TAMPA ELECTRIC

September 2, 2010

Re: Request for Additional Information, File Number 0570039-045-AV
Big Bend Power Station
Simple Cycle Combustion Turbine (SCCT) 4A and SCCT 4B Project
Railcar Unloading System Project

# Performance Curve Pipeline Natural Gas

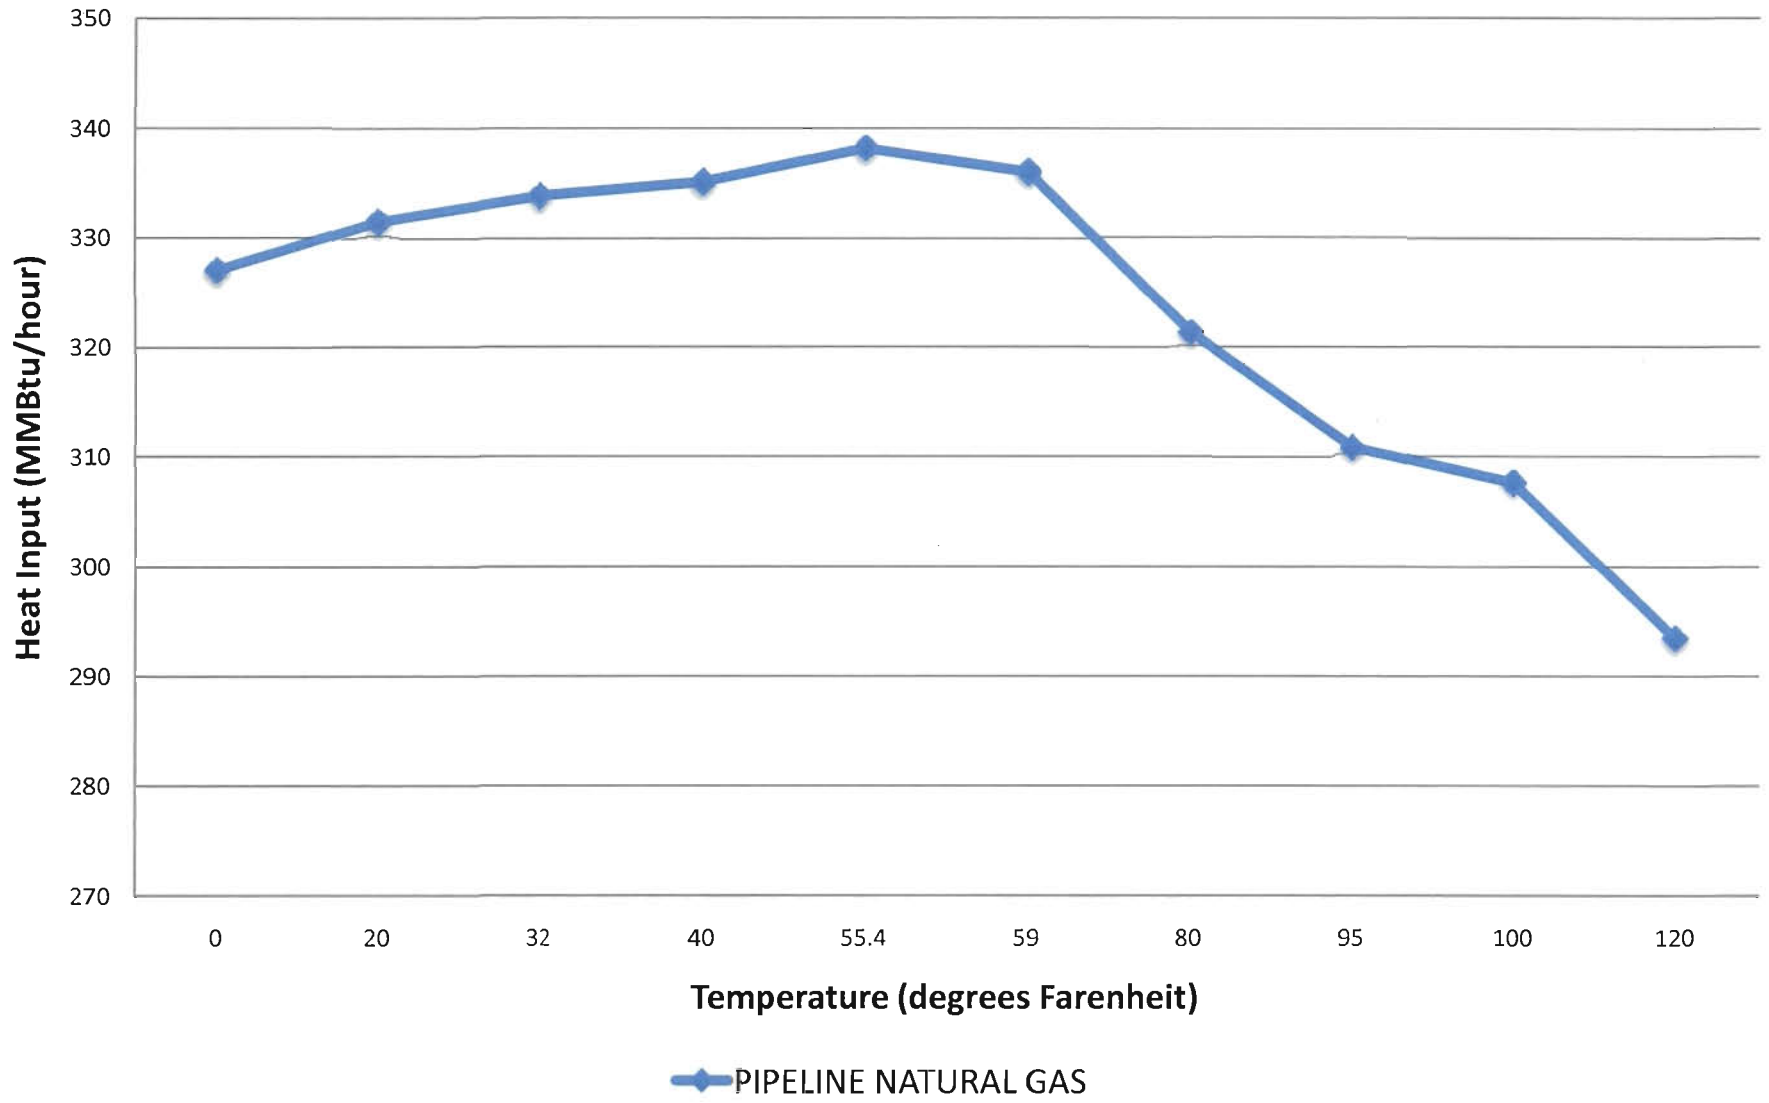
*Permit No. 0570039-040-AC, specific condition number III. 7 required the manufacturer's performance curves to be submitted, I was unable to locate them on file with the Department; please provide.*

The performance curves were submitted on November 18, 2009, to the local compliance authority. Please find the performance curves in Attachment B.

Temp	MMBtu/hr
0	326.9479
20	331.4151
32	333.7689
40	335.0164
55.4	338.1
59	335.937
80	321.3363
95	310.8268
100	307.5235
120	293.349
Slope	-0.30654
Intercept	341.8572
